Hi-Fi Products  
Service Bulletin

Model: STR-AV970X/AV1070X

No. 238

Subject: Hissing Noise In Rear Surround Channel

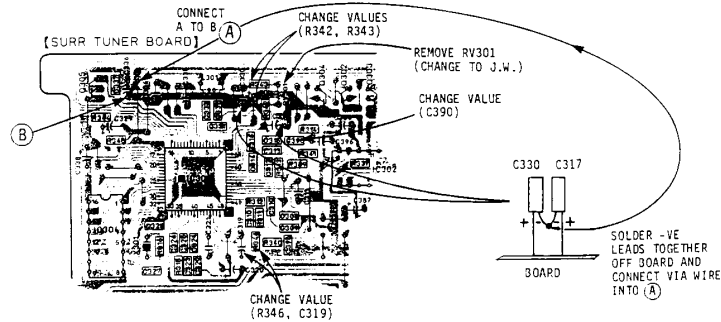
Symptom:  
(54)

The rear surround channel has a high frequency hiss present which is most noticeable with the master volume turned up to at least 50%, the rear channel level at 0dB and no signal source present.

Solution: If this symptom occurs, perform the following:

1. Change resistors R342 and R343 from 330K to 220K.
2. Remove pot RV301 and replace it with a wire (short).
3. Remove the negative leads of caps C330 and C317 off the board and solder them together (off the board), then solder into them a wire from the Digital ground. Then connect the digital ground into the analog ground as shown.
4. Change C390 from 0.22 $\mu$ F to 10 $\mu$ F.
5. Change C319 from 4.7 $\mu$ F to 1 $\mu$ F.
6. Change R346 from 100K to 10K.
